**TIM
MILLER
ASSOCIATES, INC.**

Re: Meadowbrook Estates Subdivision, Response to Traffic Comments

TO: Mark Edsall, P.E.
FROM: Philip J. Grealy, Ph.D., P.E.
DATE: April 2, 2003
RE: Meadowbrook Estates
Town of New Windsor/Town of Cornwall, New York
PROJECT: No. 676

Figure 4: Sensitivity No Build AM Peak Hour Traffic
 Meadowbrook Estates
 Towns of New Windsor and Cornwall, Orange County, New York
 Base Map: NYSDOT Cornwall Planimetric Quad Map, 1985
 Scale: 1" = 2000'

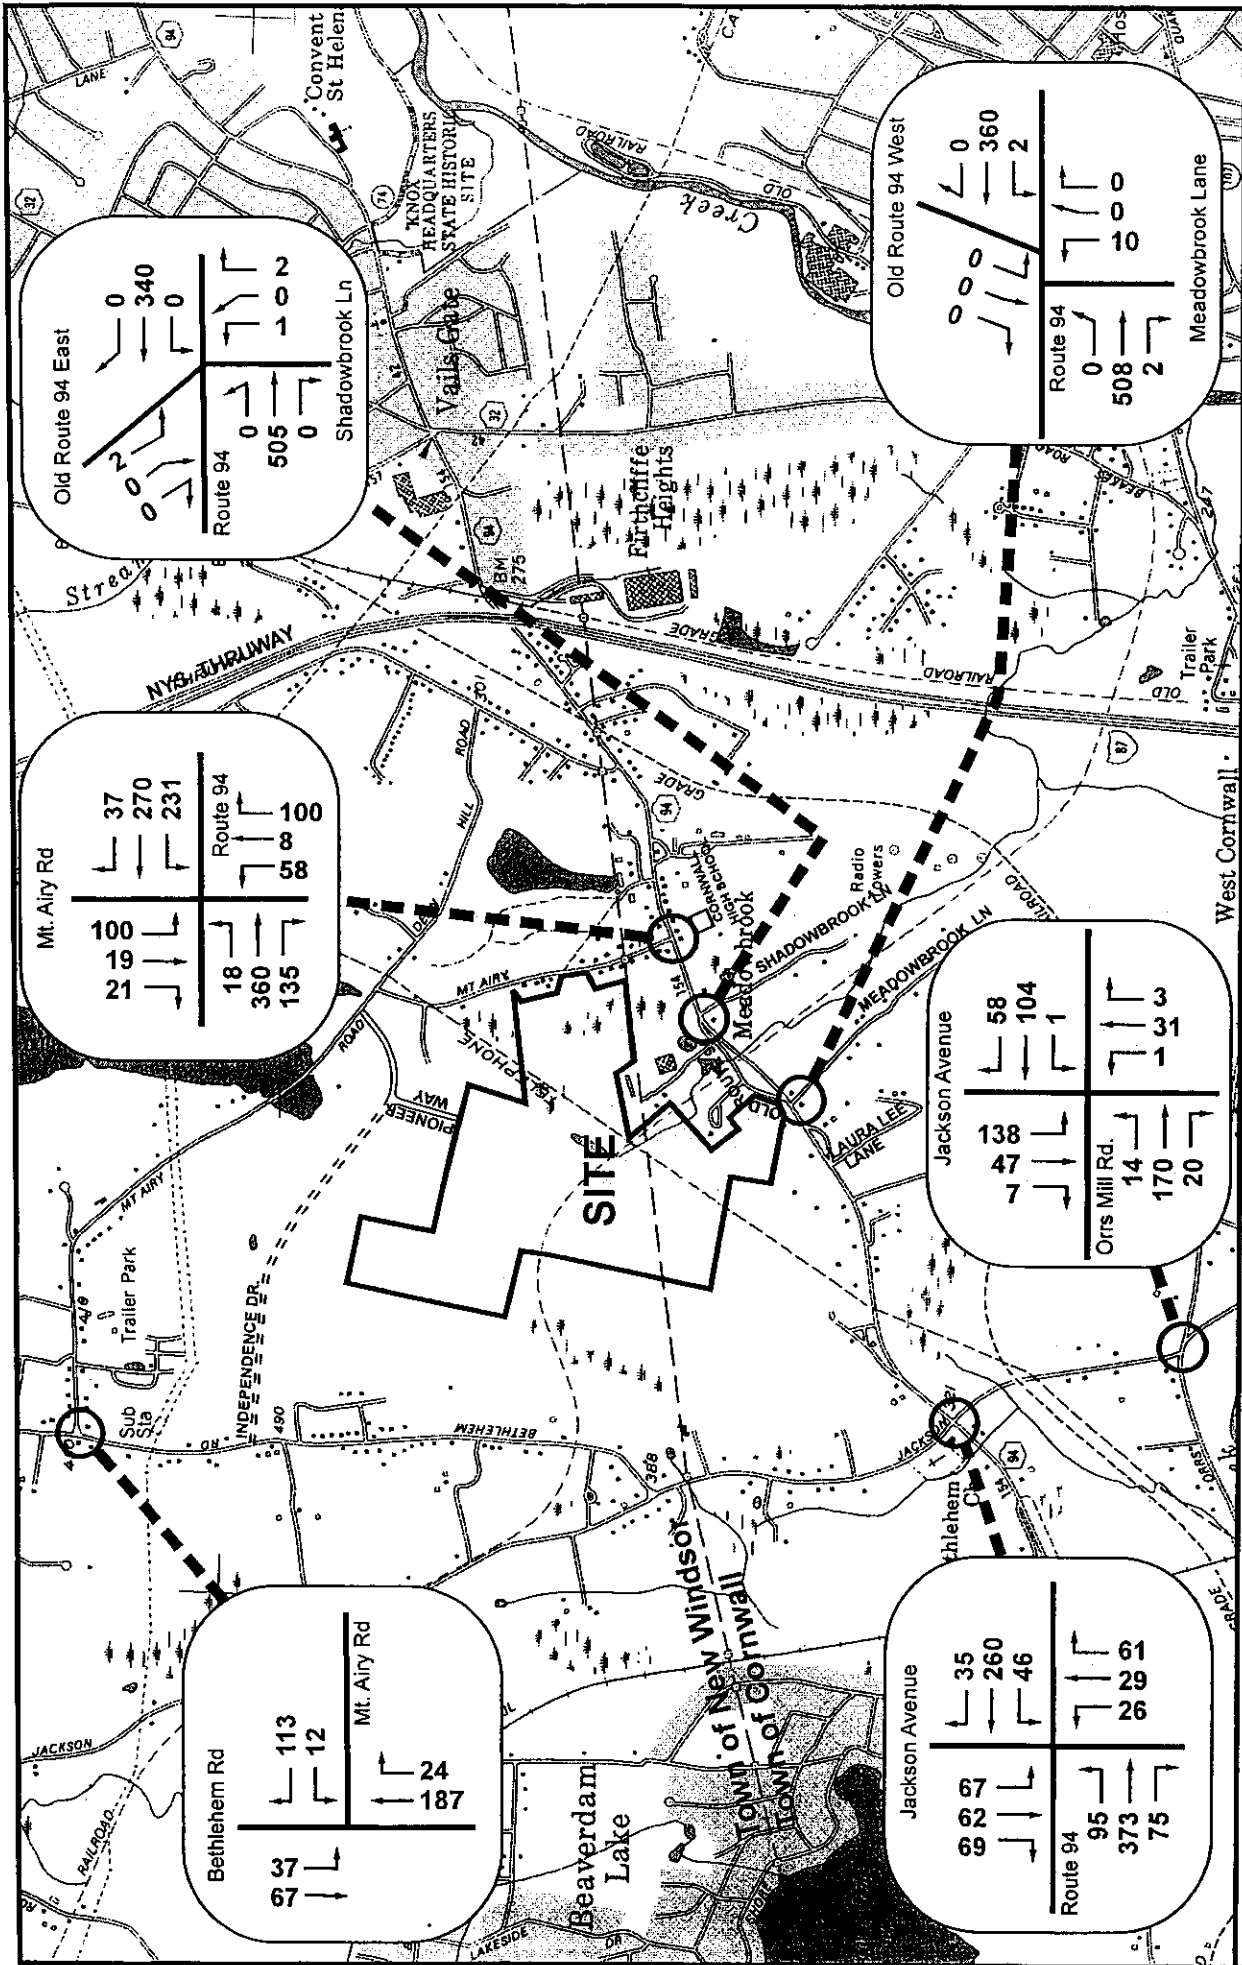
- 6 o Traffic for other proposed developments in the area was included as part of the No-Build Condition including traffic for The Reserve. However traffic for the recently approved Hannaford Supermarket was not included. A sensitivity analysis to include traffic for the Hannaford Supermarket should be provided. This may be significant for the Route 94 and Meadowbrook Road (East) intersection.

Response 6: The traffic to and from the Hannaford Supermarket will alter trip distribution at Five Corners. Residents shop for food daily and weekly. As residents in the NYS Route 94 corridor generally already travel on NYS Route 94 to reach shopping opportunities in the Five Corners areas, many of these Hannaford trips are already on the network. Those trips are diverted trips or passby trips already on the NYS Route 94 corridor west of Five Corners.

A sensitivity analysis was prepared that includes traffic from the Hannaford site as though they were new trips. These trips have been included in a revised no-build volumes in Attachment C as part of the sensitivity analysis described in Attachment B.

Figure 8: Sensitivity Site Distribution AM and PM Peak Hour Traffic
 Meadowbrook Estates
 Towns of New Windsor and Cornwall, Orange County, New York
 Base Map: NYSDOT Cornwall Planimetric Quad Map, 1985
 Scale: 1" = 2000'

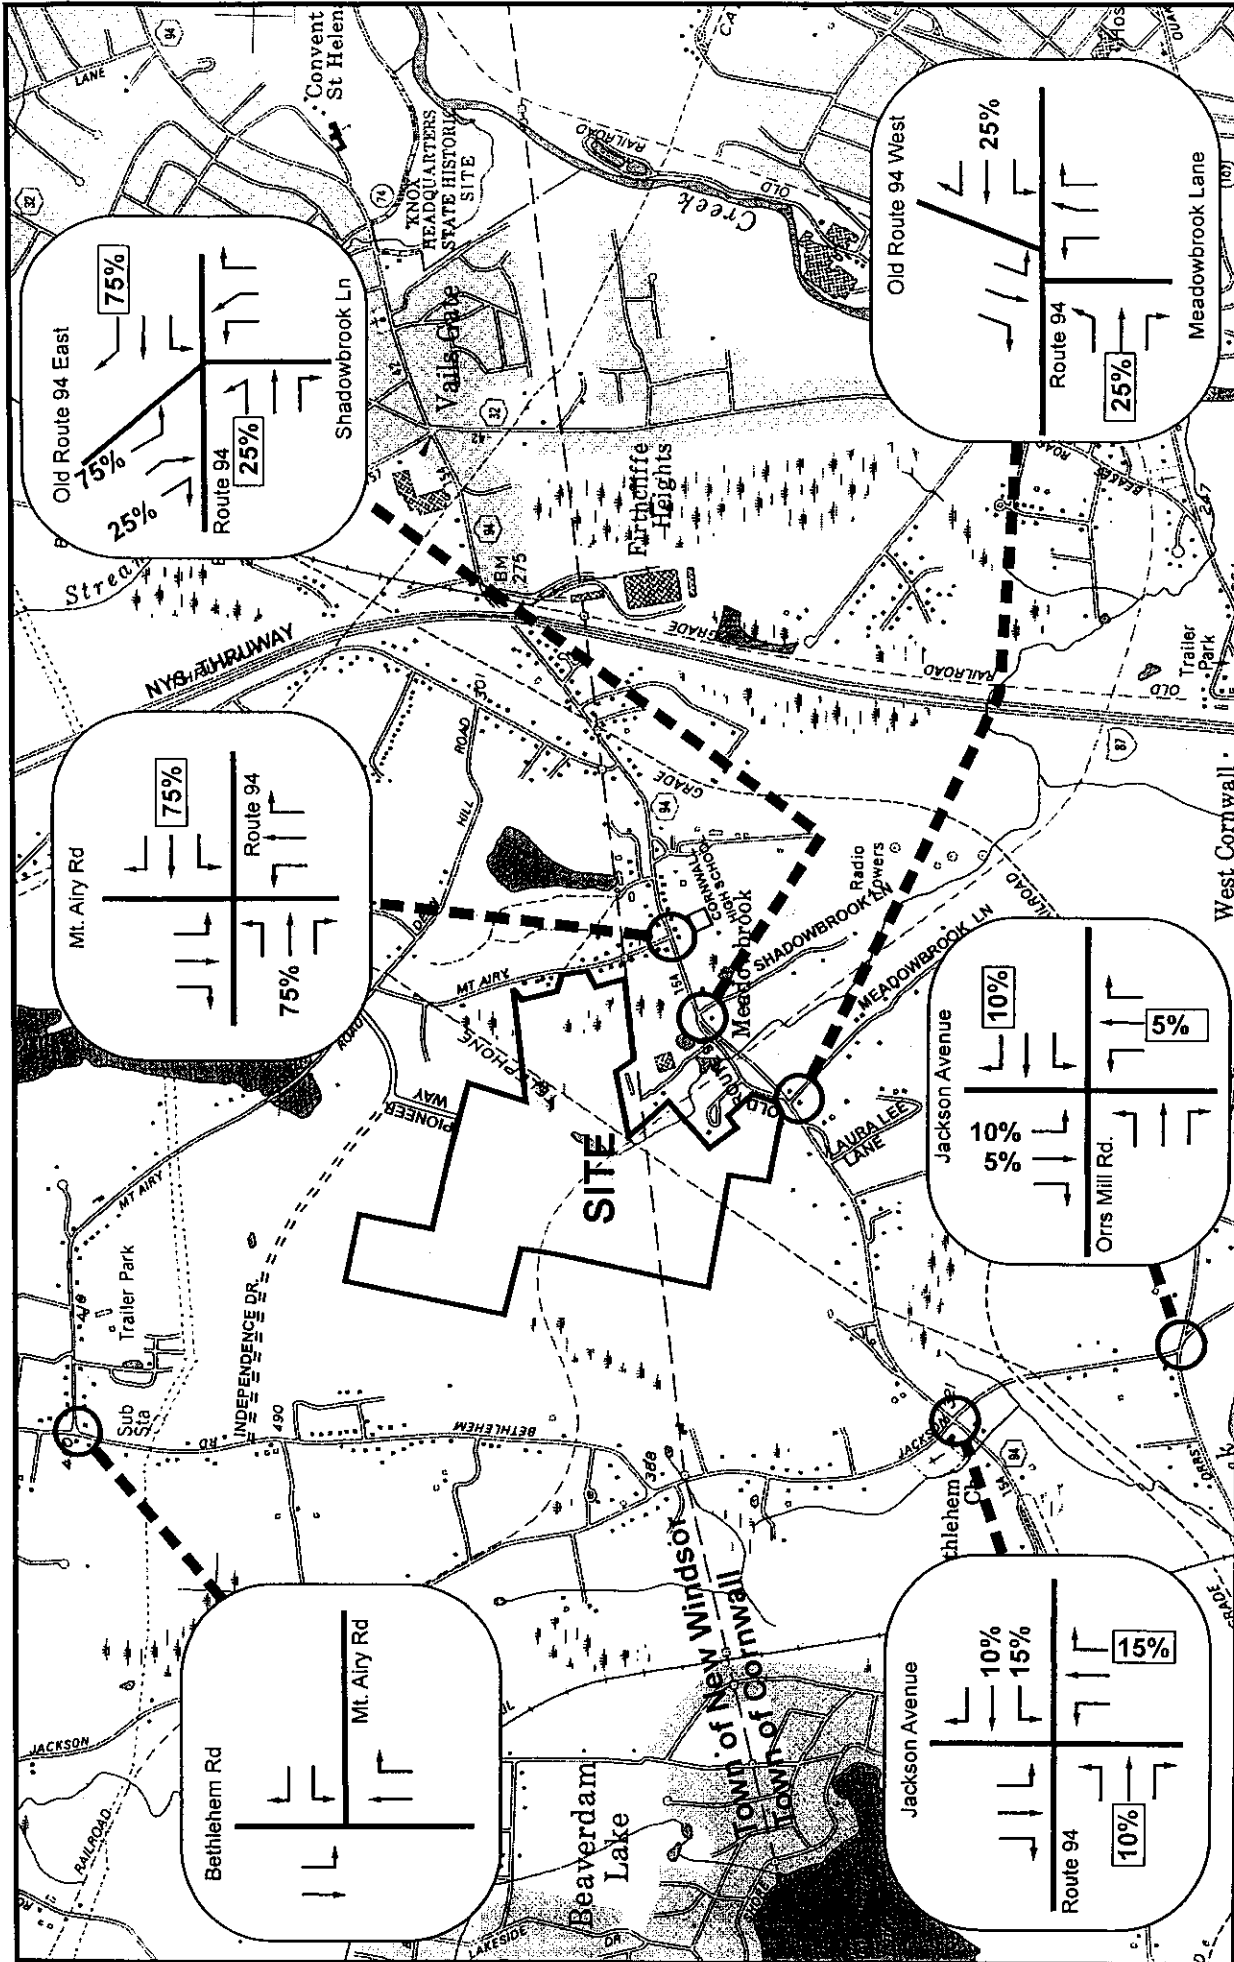
- 7 o Access to the project is proposed to Meadowbrook Road (via Route 94) and through The Reserve. It appears by the site distribution figure (Figure 8) that 45% of the traffic will arrive and depart through The Reserve with 25% via Mt Airy Road and 20% via a new roadway (Independence Drive). Noting the above, the following should be considered:

- 8 • Based on the review of the existing roadway network and existing traffic volumes, the 45% to/from Bethlehem Road appears to be high. Confirmation of the arrival and departure patterns should be provided. Depending on this information, a sensitivity analysis may be necessary assuming more traffic to/from the Meadowbrook Road access (Via Route 94).

- 9 • Assuming the 45% through The Reserve, the time frame for the completion and opening of the new roadway may be critical, especially since the Design Year for the Meadowbrook Estates project is 2005. Depending on the time frame of The Reserve and the time frame of the new roadway, a sensitivity analysis assuming all site traffic utilizing Meadowbrook Road may be required.

Peak hour congestion in the Five Corners area traffic is anticipated to continue to encourage use of the shorter and quicker routing to the Thruway interchange area via Bethlehem Road. This area contains Stewart Airport, NYS Route 300 interchanges with I-87 and I-84, the Newburgh Mall, Walmart, Home Depot and other shopping/employment destinations. To clarify the issue of road construction timing and to further examine the distribution a sensitivity analysis was completed as shown in Attachment B. This sensitivity analysis assumes that 100 percent of the site generated traffic uses the NYS Route 94 access. The alternative routing to/from Bethlehem Road the north would be via NYS Route 94 and the Five Corners intersection.

1. Additional two percent per year for three years to 2008.
2. Additional No Build traffic from Hannaford Supermarket and Five Corners' area.
3. Increased traffic at the access to NYS Route 94 equivalent to rerouting all site traffic to/from Bethlehem Road toward NYS Route 300 via Five Corners. Reserve traffic going through the site is balanced by site traffic going through the Reserve development.
